Sundry Notices and Reports on Wells

1. Type of Well GAS	5. Lease Number NM-019405		
2. Operator Meridian Oil Inc.	6. If Indian, All.or Tribe Name		
3. Address & Phone No. of Operator PO Box 4289, Farmington, NM 87499	7. Unit Agreement Name		
4. Location of Well 680'S, 2200'E	8. Farm or Lease Name Bloomfield		
	9. Well No. 3		
	10. Field, Pool, Wildcat Fulcher Kutz PC		
	11. Sec. T. R. M. or Blk Sec. 17, T-29-N, R-11-W NMPM		
14. Permit No.	15. Elevations 5718' GR	12. County San Juan	13. State NM

It is intended to plug back the Pictured Cliffs and recomplete in the Fruitland Coal formation in the following manner:

WELLBORE DIAGRAM

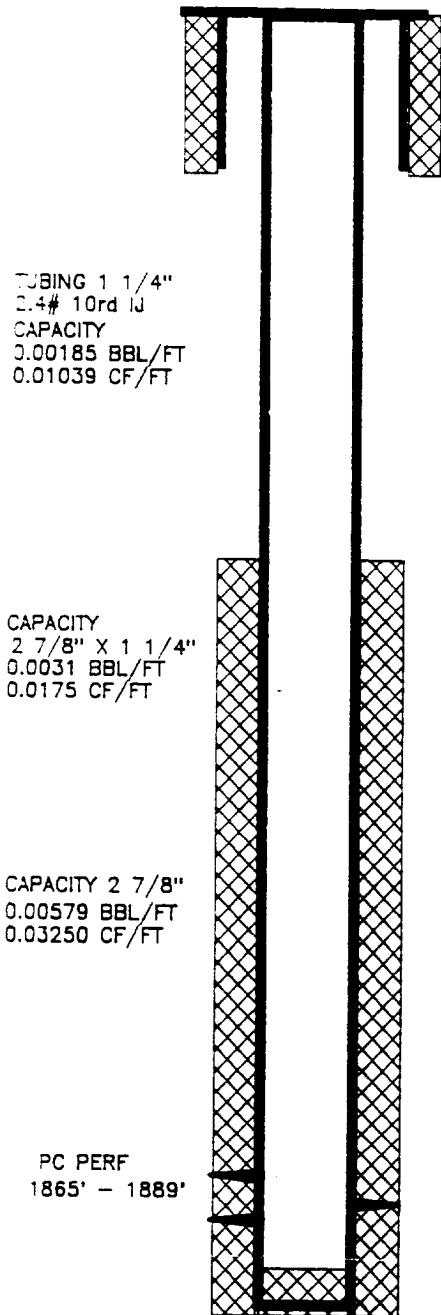
Set CIBP @ 1853'. Run CBL. Pressure test to 4000 psi. Perforate 1608-18', 1624-28', 1646-52', 1664-70', 1706-08', 1718-26', 1804-14', 1826-34' w/2 spf. Fracture stimulate well with 102,000# sand and 60,270 gal. fluid Flow well back. Land 1 1/4" tbg @ 1810'.

APPROVED
AS AMENDED

A Communitization Agreement is required
for the acreage dedicated to this well.

Squeeze the pictured cliffs perforations
with cement.
